Product Change Notification (PCN)

PCN Number	502944	Date Issued	August 17, 2017
Reason for Change	Change to Product		
Change Type Description	<p>This letter is to inform you that changes are being made to the part(s) identified in this Notice. The change may affect the fit, form, function or appearance of the parts, or it may result in a change to the specification. The pictures below show an example of the possible differences.</p>		
Reason for Short Notice	Special Request		
Assessment of Change	Test report/Specification Test Report		
Internal Molex Qualification Date	August 18, 2017		
Sample Availability Date (Changed Part)	August 18, 2017		
Planned Implementation Date	September 01, 2017		
Method of Identifying Change	Factory order number

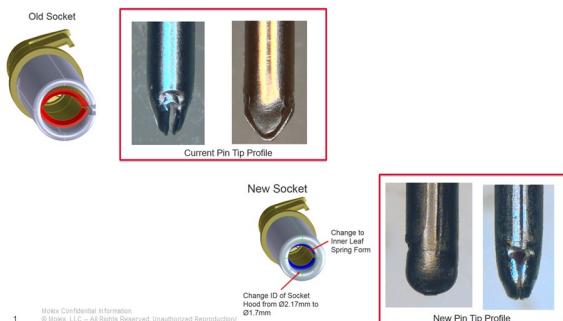
- Molex is making product enhancements to the ML-XT product range 93445-2*** to 93445-6*** and 93444-2*** to 93444-6*** to increase the functionality of the latches at extreme negative temperatures.
- Due to the variation seen on conduit covers we are also adding a small rad to the back of the protection tabs on the latches on the 93445 series.
